C2032x MAIN FIRMWARE RELEASE NOTES

Uni-7 Series with PK-260B CPU Board

C2032x supersedes B0779x as the standard Uni-7 firmware for the revised PK-260B CPU board.

The two CPU board versions can be easily identified by the expansion memory card slot located on the left side of the Uni-7. See the images below.

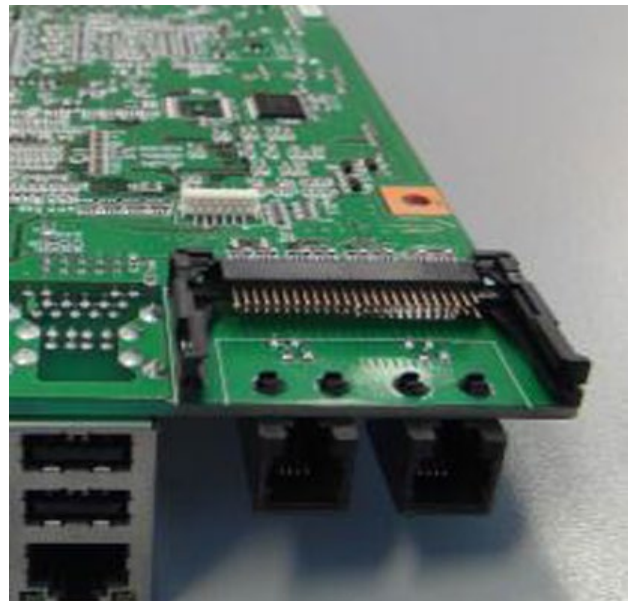
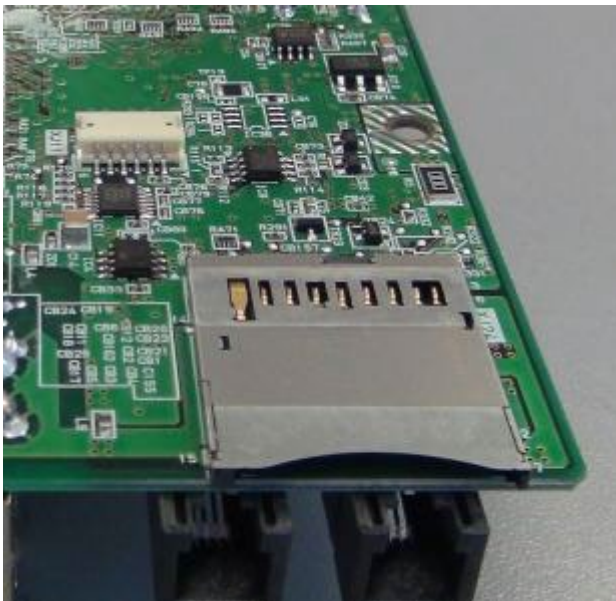
Firmware C2032x is designed for the revised CPU board PK-260B. **This firmware is not compatible with the previous CPU board PK-260A.** And previous firmware (B0674x, C1991x, etc.) is not compatible with the new PK-260B CPU board.

The new PK-260B CPU board supports SD memory card sizes 512MB, 1GB, and 2GB (p/n 174110). The maximum SD card memory that can be recognized is 2GB. A larger capacity SD card may be used but only 2GB will be available.
